# stm32-blinky — Design Document

ai-ee v1 pipeline

#### Board review: stm32-blinky (P8 adversarial pass)

reports/renderers/stm32-blinky\_top.png

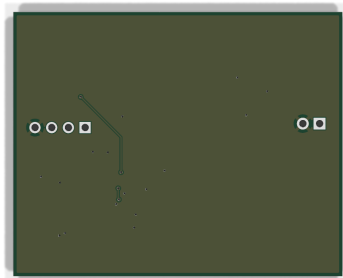
#### ERROR 1 - J1 power input has no polarity legend on silk (requirements miss)

requirements.md sec 2 and architecture/blocks.md both promise the 5 V input "polarity marked on silkscreen" (J1 pin 1 = +5 V, pin 2 = GND). The as-built board has NO text or +/- legend anywhere: silk carries refdes only (there is not a single gr\_text on the board). What exists at J1 is a pin-1 dot and a square pad (see crop-j1\_d1.png) - and the dot sits on the header body outline,

so after the header is soldered the plastic covers it. Post assembly the top side shows nothing but "J1"; the square pad is visible only from the bottom.

Consequence: the unkeyed 2-pin input can be plugged backwards with no on-board hint. D1 (series SS34) prevents damage - reversed input just does not conduct - but the user gets a dead board and no way to know why or which way is right without opening the design files. This is the board's primary human interface and an explicit requirements promise. Fix is two silk texts ("5V", "GND" or "+", "-") next to the holes, outside the header body. Must fix before fab; there is ample empty silk area (left region is empty).

#### **WARNING 1 - J2 SWD pins unlabeled (architecture promise miss)**

`blocks.md` promises "Canonical pin order (silk-labeled): 1 = SWDIO, 2 = SWCLK, 3 = 3V3, 4 = GND". Electrical order verified correct from the netlist (pads: SWDIO/SWCLK/+3V3/GND, U1 PA13/PA14 to pins 1/2). But there are no labels - only a pin-1 square cell (`crop_d2_j2.png`) which the header body covers after assembly. ST-Link clones are wired pin-by-pin; swapping 3V3/GND shorts the debugger's 3.3 V rail to ground. Same trivial fix as ERROR 1 (four small silk texts below the header row - the area under J2 is clear). Strongly recommend fixing together with ERROR 1; warning rather than error only because requirements.md itself demands the ORDER (met), the labels are an architecture-level promise.

#### **WARNING 2 - refdes association ambiguity (cap cluster + C3-under-J2)**

- "C11" text sits directly above R1's body; "C1" text below-left of R1; "C7"/"C8" labels float between parts they do not touch. Among these 0603s are four DIFFERENT cap values (22 pF, 10 nF, 100 nF, 1 uF) plus a 1 k resistor - a hand-rework or debug probe guided by silk has a real chance of landing on the wrong part.
- "C3" text renders directly under J2 pads 3-4 and reads like a header label (its own body is 3.6 mm away). Mildly reinforces the J2 labeling problem: someone may read "C3" while counting SWD pins.

NOT waivable in this reviewer's judgment: ERROR 1 (J1 polarity legend) - explicit requirements promise, primary user interface, zero-cost fix.
